Submission on the EIS for the Proposed Traveston Crossing Dam (Stage 1)

January 2008

Introduction and overview of MRCCC comments on the Environmental Impact Statement for the Proposed Traveston Crossing Dam

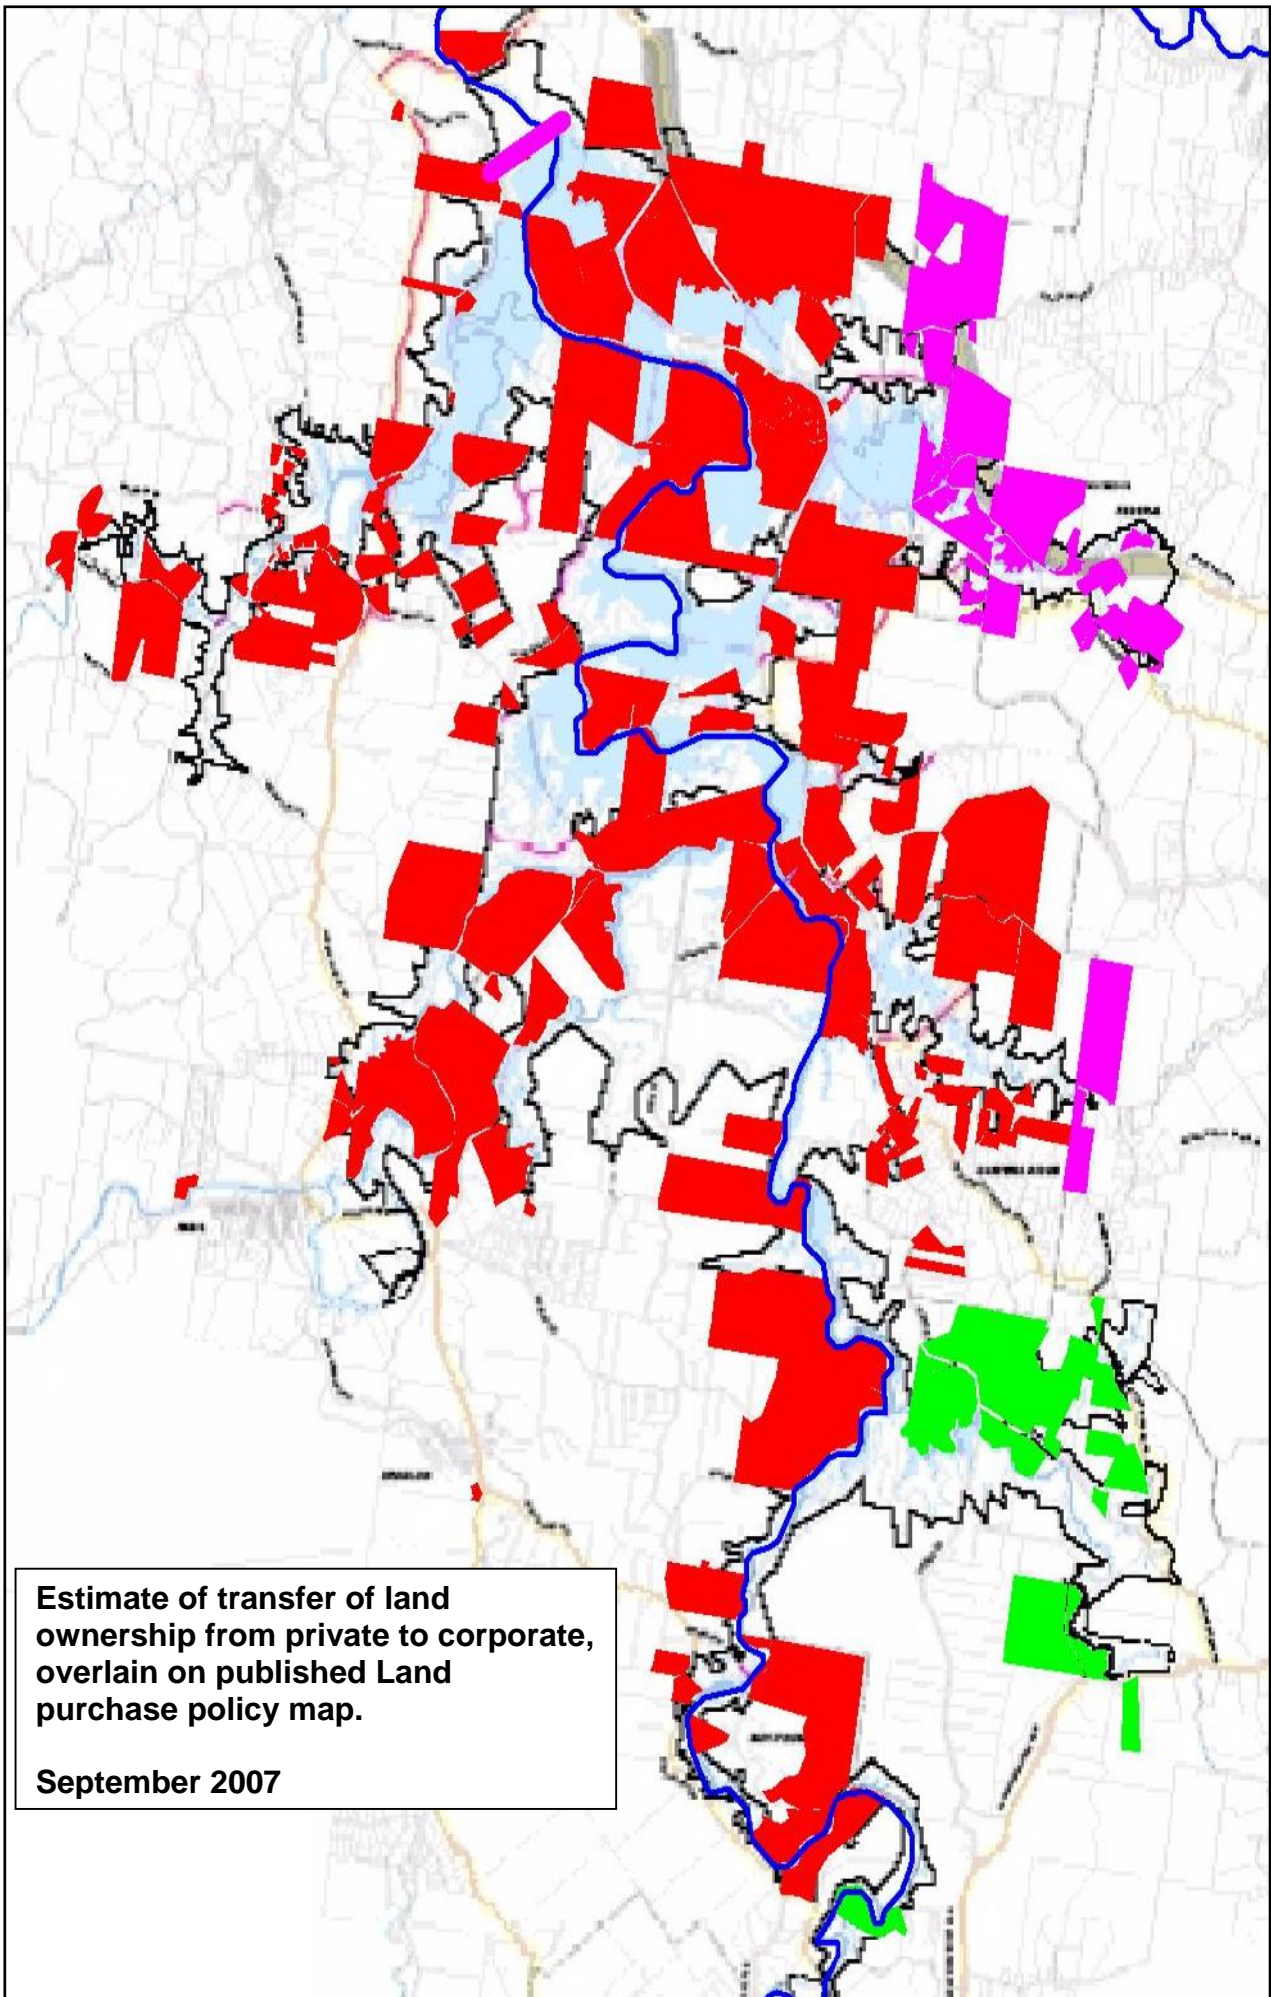
The map on the next page gives an insight into the extent of the impact that the proponent has already had on the landholders and communities in the proposed inundation area. This figure shows a map of properties that had been purchased for the project up to mid September 2007. It can be seen that the proponent had already targeted properties outside their stated land purchase plan and well outside the Stage 1 project area defined in the EIS. In fact, the land purchased already amounts to more than 7265ha at a cost of more than 275 million dollars, involving more than 400 properties. This compares with the figure of 241 million dollars quoted for the total stage 1 land purchase cost in the chapter 2 of the EIS, a figure of 334 properties 'affected' by stage 1 quoted in chapter 4 of the EIS and the total stage 1 project area quoted as 7277 ha., including all roads and infrastructure.

It is clear that the description in the EIS of the area of land, number of properties and cost of land acquisition directly required by stage 1 of the project understates the scale of the actual impact that the proponent has already had on land holders in the Mary Valley. This level of impact is quite extraordinary considering the project has not yet been subjected to a social or environmental impact assessment and it has not been granted approval to proceed under either State or Federal law.

Figure 3. Comparison between storage behaviour presented in the EIS with the data presented to the 2007 Senate Inquiry. (Proponent's data digitized from EIS figure 2.3 and Qld Gov. evidence published in Senate Inquiry)

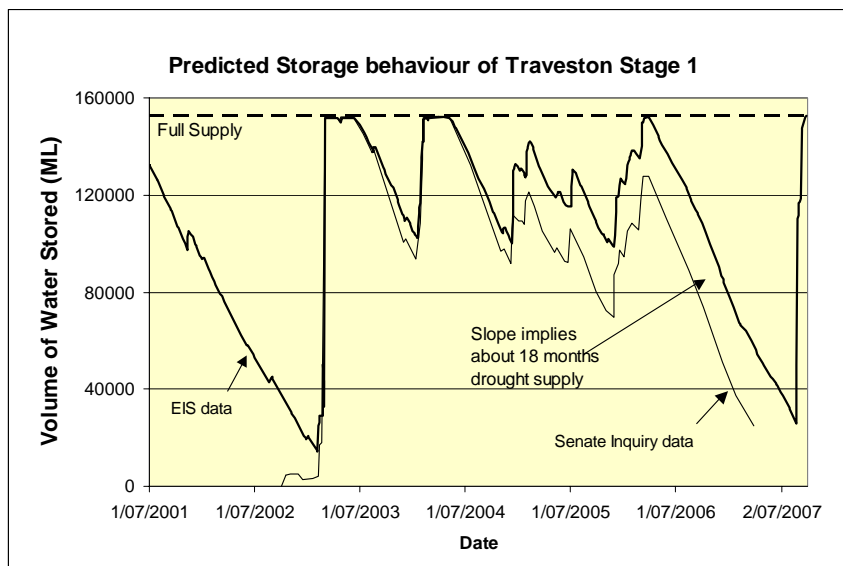
Shows discrepancy between storage data presented by the proponent to the senate inquiry and storage data presented in the EIS. Slope indicates how quickly the storage would be drawn down in periods of low inflows.

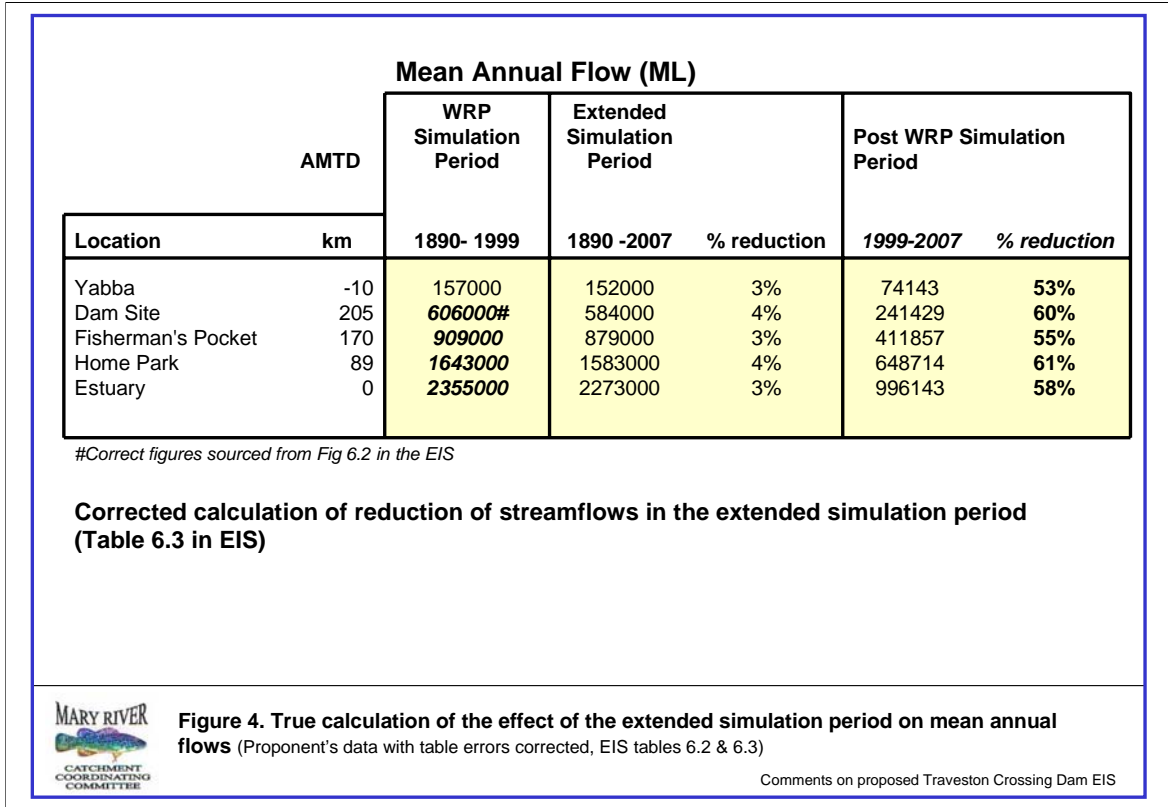
Table shows the correct figures that should have been presented in figure 6.3 of the EIS. The analysis as attempted to be portrayed in figure 6.3 does clearly communicate the effect of recent dry years on the streamflow resource at the damsite. It is useful to consider that stopping all streamflow absolutely for the period 2000-2007 could only reduce the 1890 to 2007 average by 6%. However, the proponent's figures show that streamflow since the end of the simulation period used to formulate the WRP has been greatly reduced (53-61% reduction)
